Great Lakes UK Limited
Great Wolf Lodge, Chesterton, Bicester

Non Material Amendment (S.96a) Application
Design Changes

March 2023

Proposed Amended Scheme - Third Floor

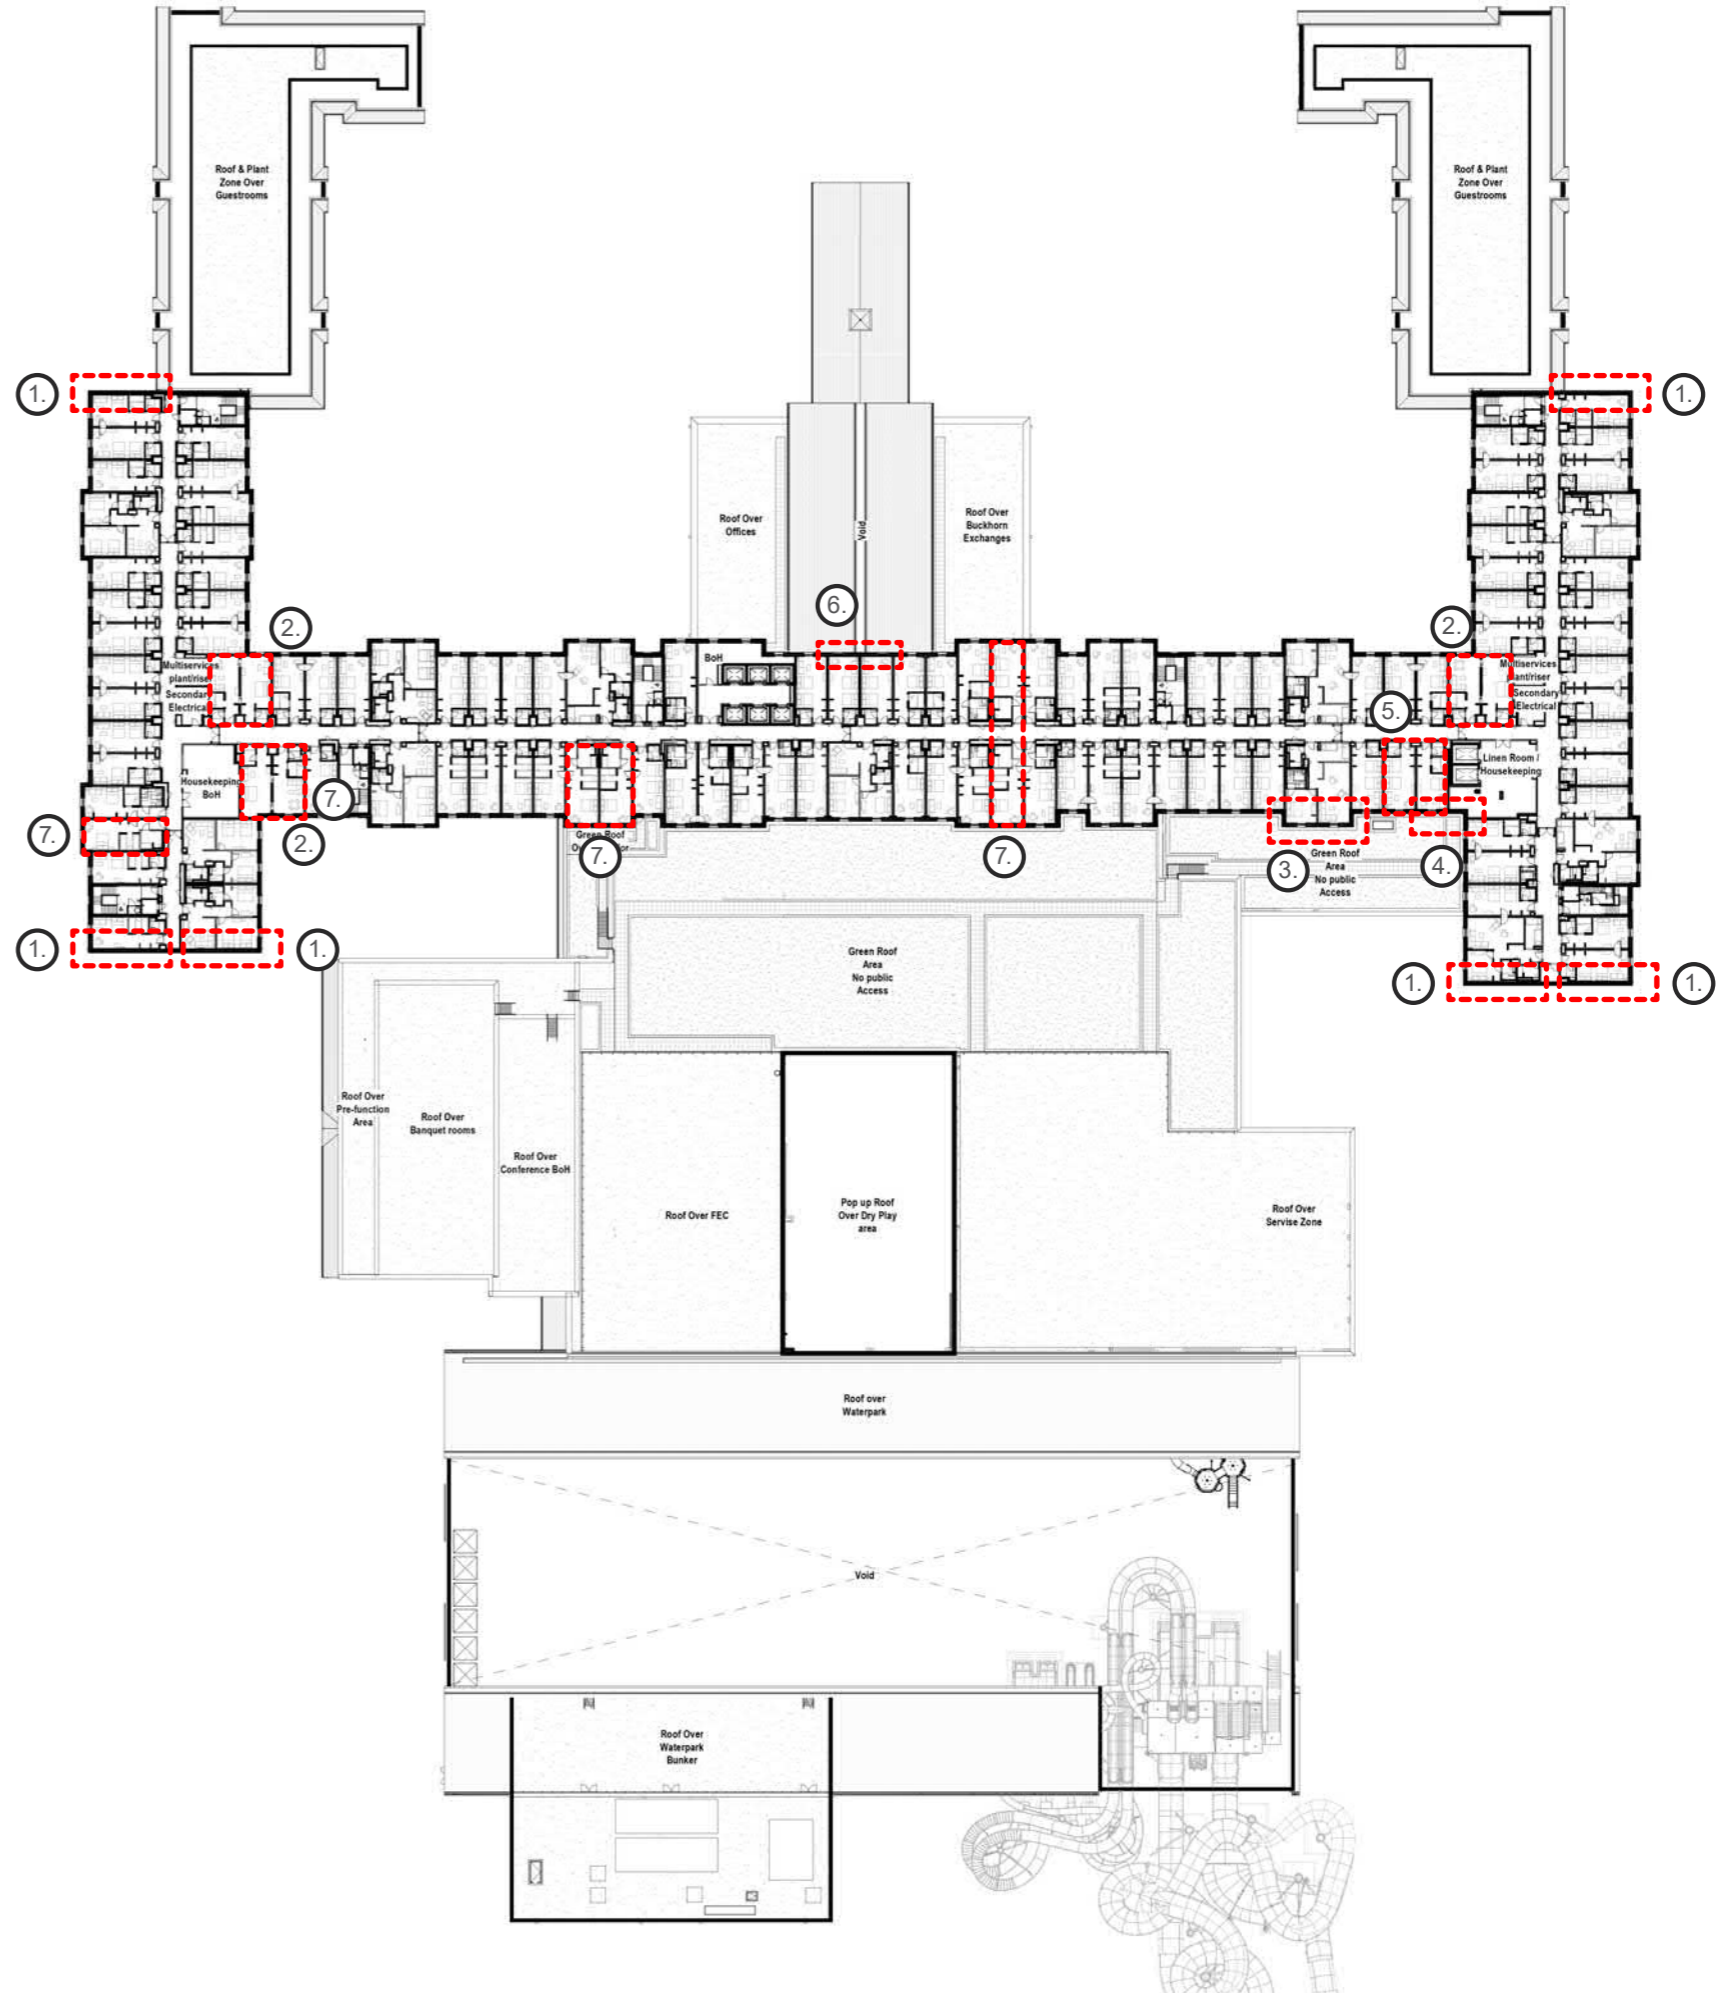
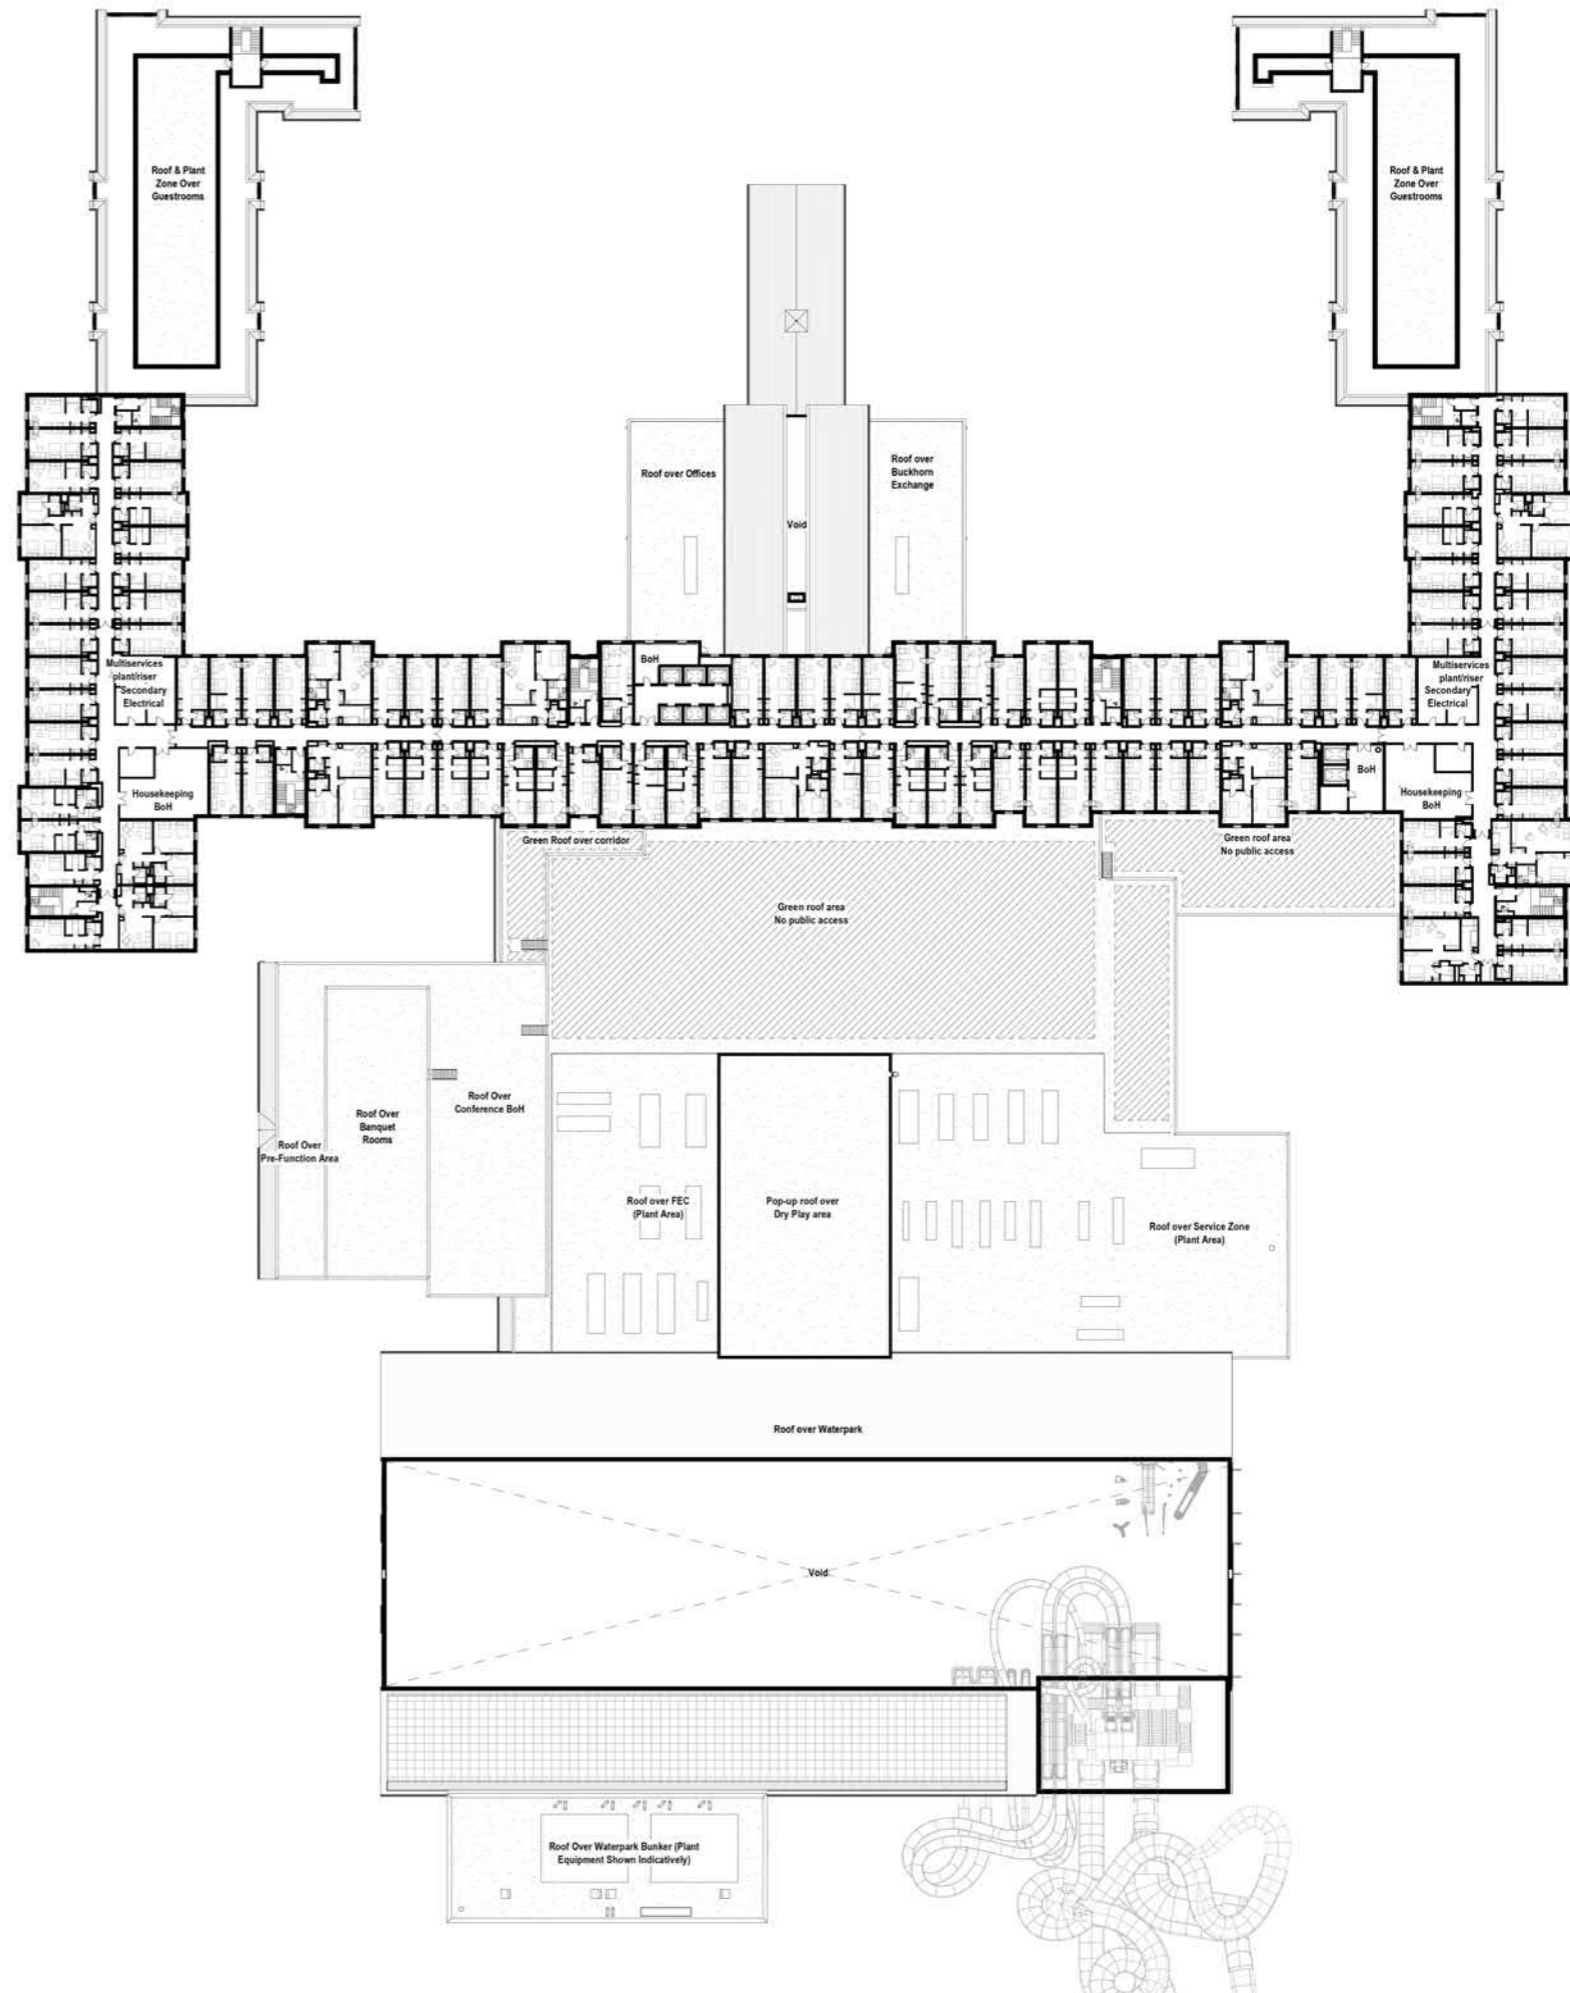
- ① Facades pushed out to allow columns not to protrude into guestrooms.
- ② Corner guestrooms changed to new enlarged types on every floor. 12 no. total rooms affected but no increase in room numbers with this change and no facade changes.
- ③ Façade wall moved down 100mm to align with equivalent wall on left hand side.
- ④ 2x Windows added on levels 1-3 and door added on right on level 1 to provide safer roof access.
- ⑤ 6 No. total additional keys added where shown on levels 1-3. Total guestroom count to be 504.
- ⑥ Window heights and sill height updated to avoid clash with reduction in roof line and weathering detail.
- ⑦ Adaptable and hoist provisions to be installed post completion when required.
